MEMORANDUM

From:	Built Heritage Officer		
Service	Green Infrastructure	App No:	250220 + 250221
Address:	36 & 38 Rose Street, Wokingham, RG40 1XU.		
Proposal:	250220: Householder application for the proposed demolition of the existing conservatory, replacement of 3 no. flat roofs and repairs to 2 no. pitched roofs at the rear, installation of new front canopy roof plus changes to fenestration and erection of garden fencing. 250221: Application for Listed Building consent for the proposed demolition of the existing conservatory, replacement of 3 no. flat roofs and repairs to 2 no. pitched roofs at the rear, installation of new front canopy roof plus changes to fenestration, refurbishment, and internal repairs.		
Heritage Asset:	36-38 Rose Street – grade II status listed building, since 1969. Wokingham Town Centre Conservation Area. Listed Buildings and Conservation Areas are classed as designated heritage assets under the NPPF (2024) and in the Council’s Local Plan policies.

Summary Of Recommendations

Extract of drawing P003.10-134 Rev.02 Proposed South West Garden View

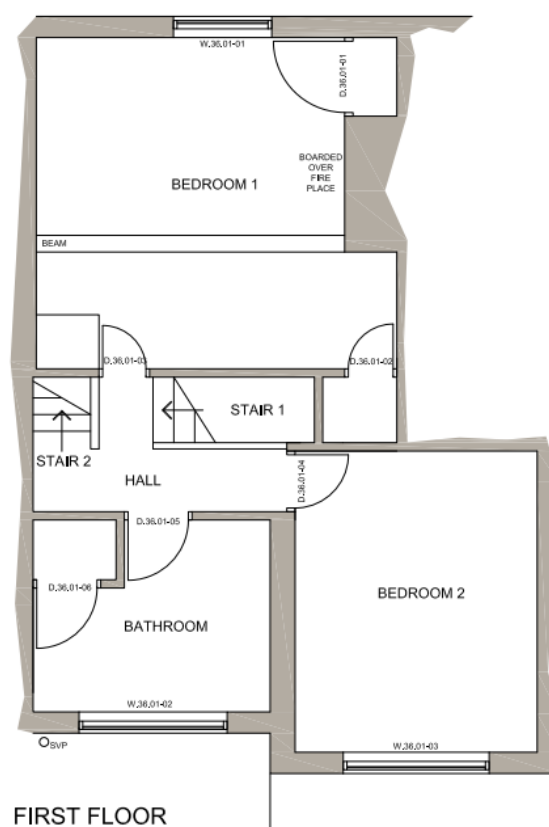
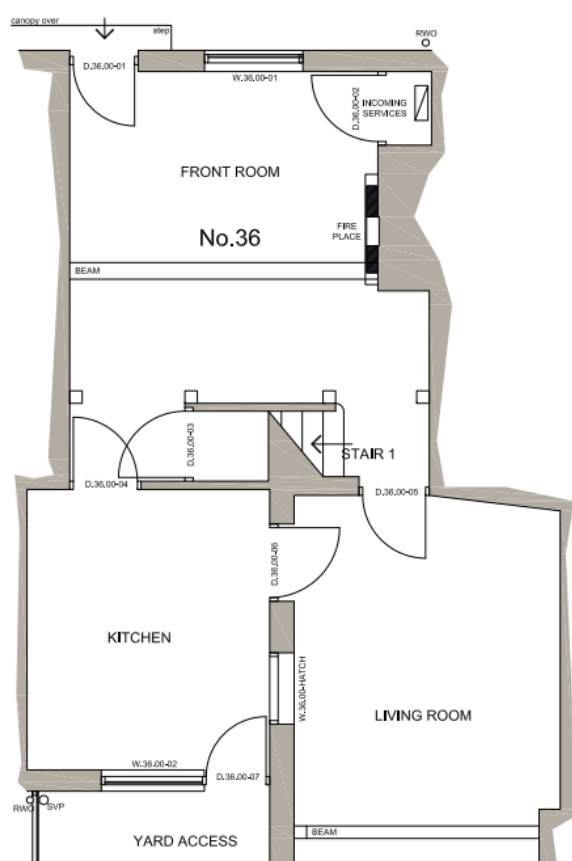
- With respect to drawing p003.10-134 Rev.02 Proposed South West Garden View – there appears to be two issues with the details as shown,
 - Whilst seemingly correctly show on the floor plan drawing- the depth of projection of the historic gabled two-storey rear range to the modern infill between nos36 and 38 is however shown somewhat narrower in the elevation view.

- The length of the high parapet wall to the 20th century flat roof extension is incorrectly shown in length and as drawn, as rather than abutting onto the end gable wall is show (with the removal of the previously shown conservatory roof section on the previous rendition Revision 01) as if it extends past the end of the gable wall, which in the photograph below is clearly not the case. With the raised section of parapet walling being shorter in length than depicted in the elevation drawing.

Extract of drawing P003.10-011 Rev.00 Proposed Floor Plan No.36 All Levels

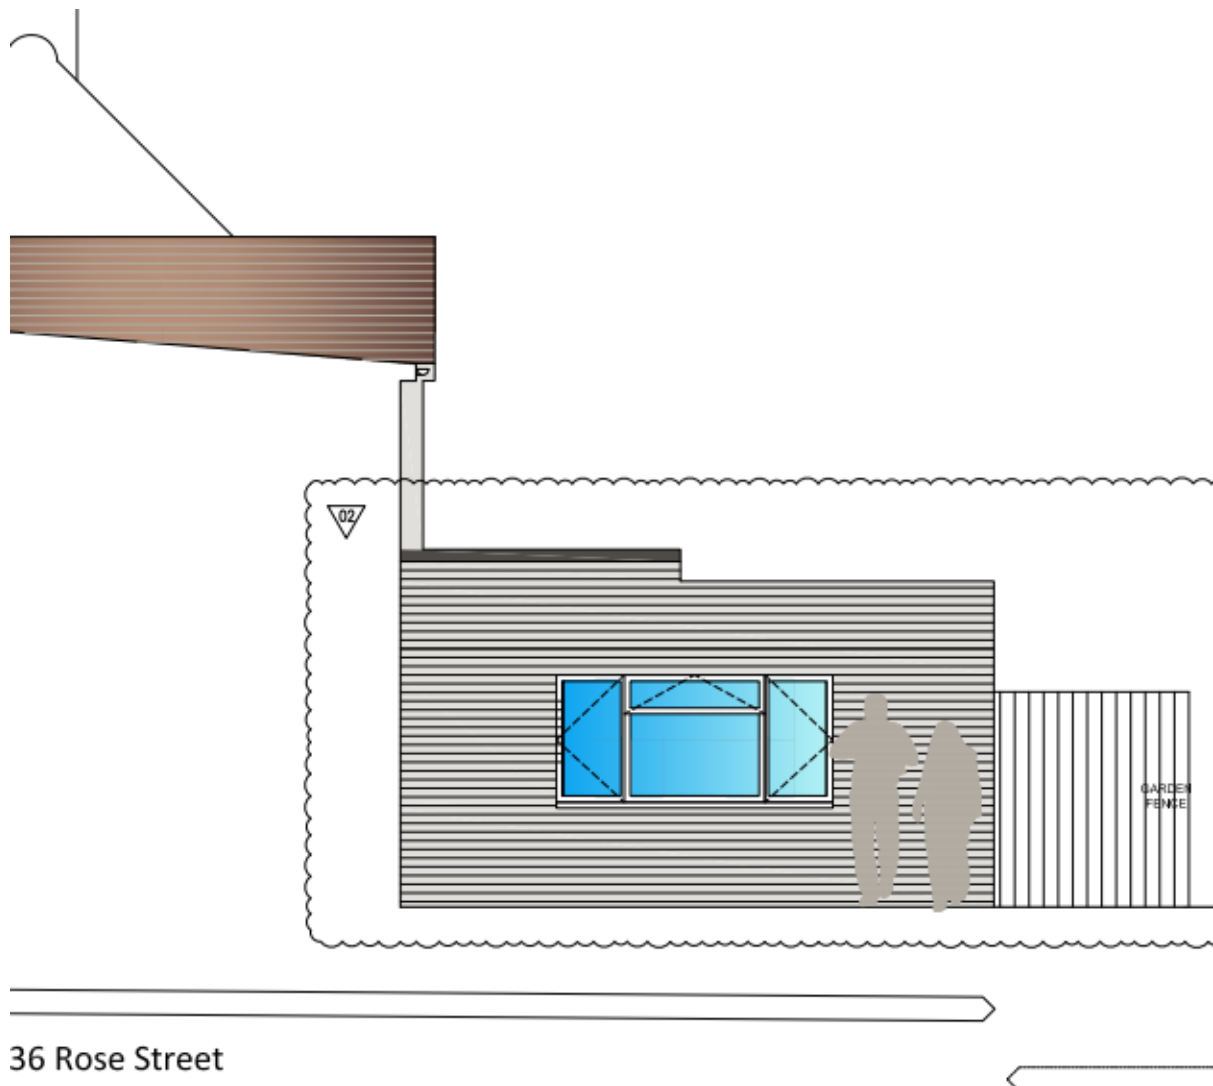
For both these applications and the earlier still to be determined applications of 242929/242930, the existing and proposed floor plans for No.36 Rose Street – with respect to the historic rear gabled two-storey element of No.36, which at ground floor level has been extended by a 20th century flat roofed extension to it. Here it is noted that:

- Whilst all sets of the floor plan drawings set the front build line of the ground and first floor on the same horizontal axis it is however noted the line of the rear first floor gable end wall does not seem to align with the nib return/ beam spanning the removed ground floor walling, which seems to extend further out than the line of the first floor end wall.
